ADDENDUM NO. 1

PROJECT NAME: Wick Alumni Center Life Safety & HVAC Improvements
UNL PROJECT NUMBER: C120P021
BID INVITATION NUMBER: 2222-13-7200

CONSULTANT: Farris Engineering
ADDRESS: 818 P Street, Suite 100

DATE OF ISSUANCE: September 3, 2013
DATE OF BID OPENING: September 18, 2013

SHEET TITLE
MECHANICAL DETAILS

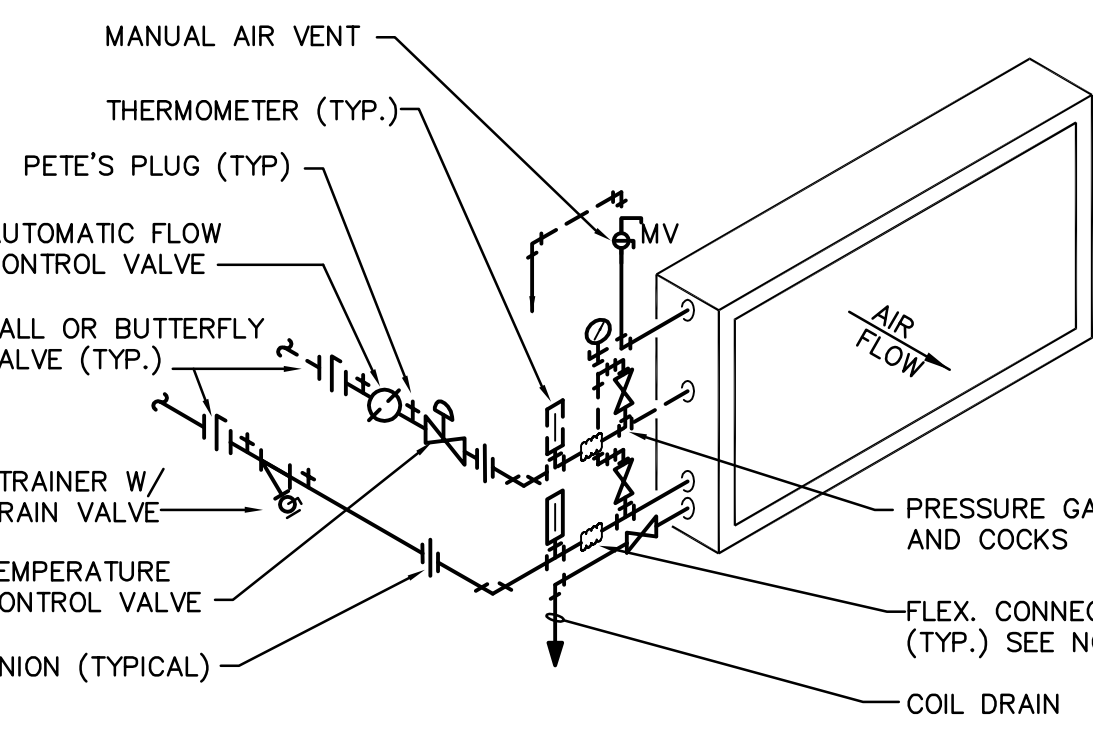
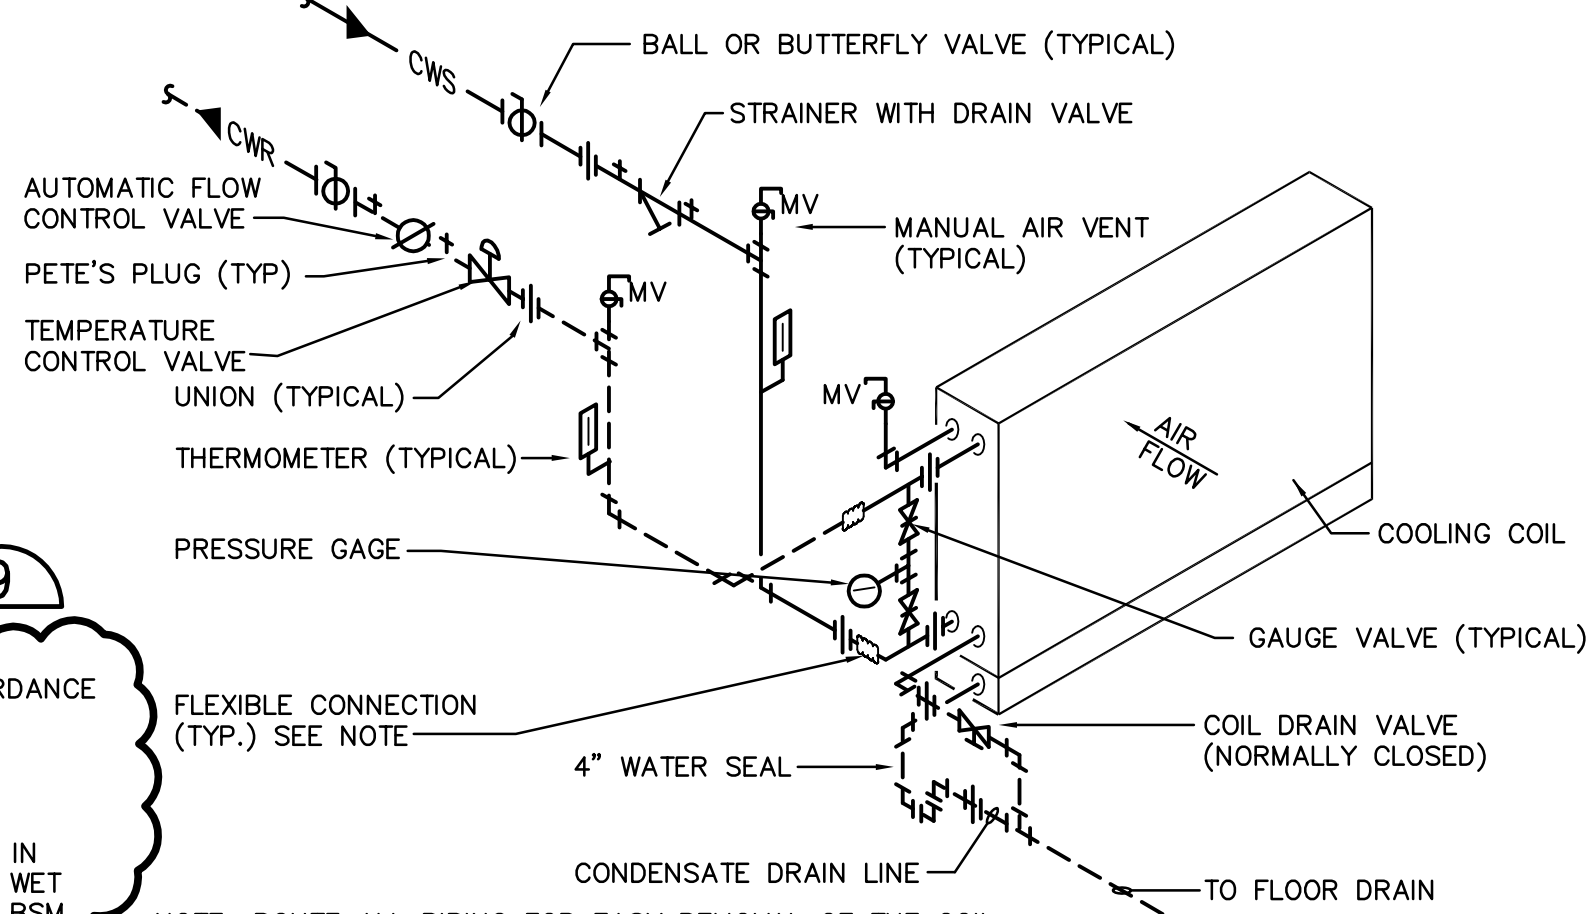
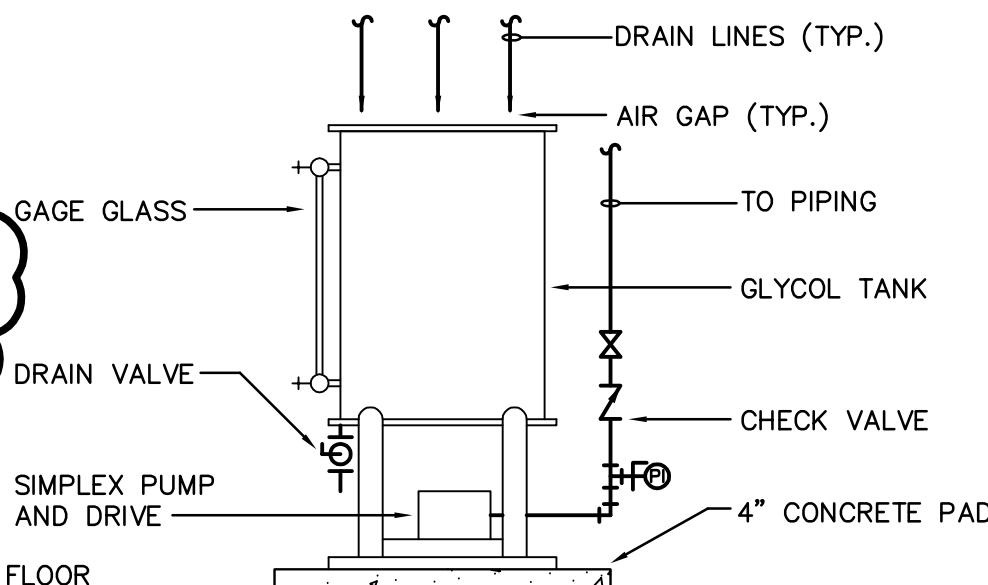
- A. This sheet has been reissued in its entirety as a part of Addendum No.1.
 - B. "STEAM PRESSURE REDUCING STATION DETAIL" has been revised.
 - C. "DUPLEX CONDENSATE PUMP DETAIL" has been revised.
